## MEMORANDUM

**SUBJECT:** Review of the following:

Re: Plan Commission Submittal Comments–May 27, 2025  
Preliminary Plan Review Comments for The Legacy at Bristol  
Tax Key ID 37-4-121-123-0802  
Village of Bristol, Wisconsin (Village)

**Figure 6: Shore Yard Setback**

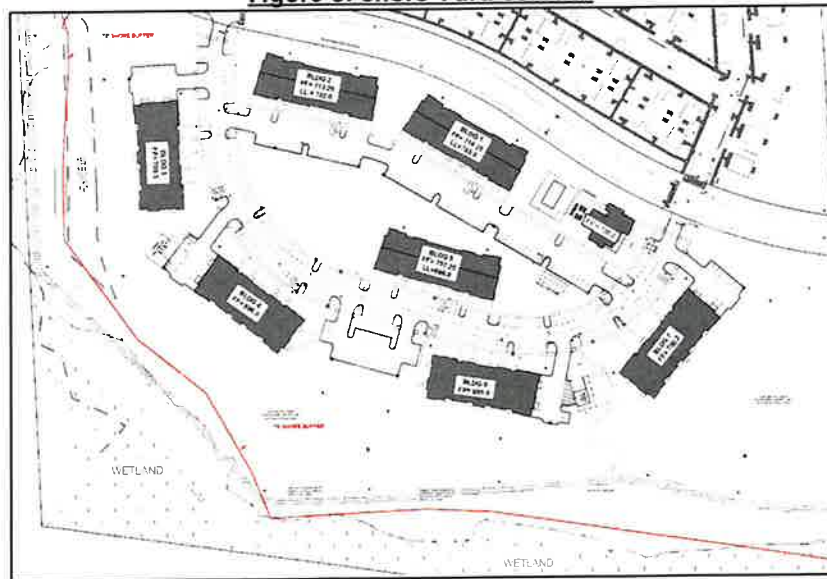
- a. *The proposed site plan conforms to the dimensional standards for the zoning on the Subject Property*
- b. Note, first floor area of proposed units may change if unit count is revised to conform to the PUD limit of 40 units per structure. This should result in a unit size increase, which would still conform.
- c. Note, the Applicant submitted an exhibit on May 19, 2025 demonstrating conformity with the shore yard setback (Figure 6).
